Dakota Westmoreland Corporation

Revision No. 25

Dakota Westmoreland Corporation has completed responses to your midterm review of Surface Mining Permit KRSB-8802 for the Beulah Mine as required by NDAC 69-05.2-11-01.

APPLICATION FOR REVISION OF PERMIT TO ENGAGE IN SURFACE COAL MINING AND RECLAMATION OPERATIONS PUBLIC SERVICE COMMISSION RECLAMATION DIVISION SFN 10562 (Rev. 12-99)

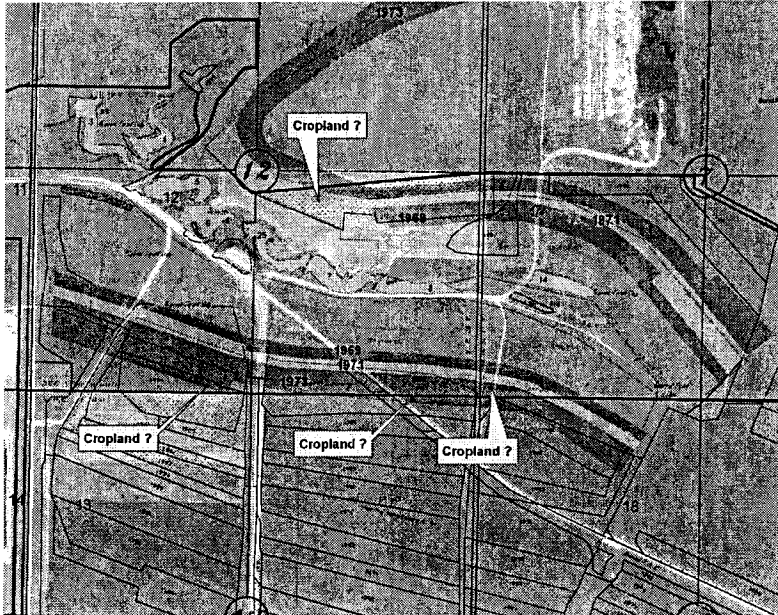
10. Please revise the narrative describing the flow direction of the Schoolhouse Bed on page 2.3.13. The narrative references and interprets the Schoolhouse potentiometric map and describes the flow direction to be generally south and east, and although limited data is available, it appears that the flow direction is predominantly to the south and west according to the map. (BEB)
 - The narrative has been revised to conform with the potentiometric map of the Schoolhouse Bed (Exhibit 2.3.6) which demonstrates flow in a northwesterly direction.
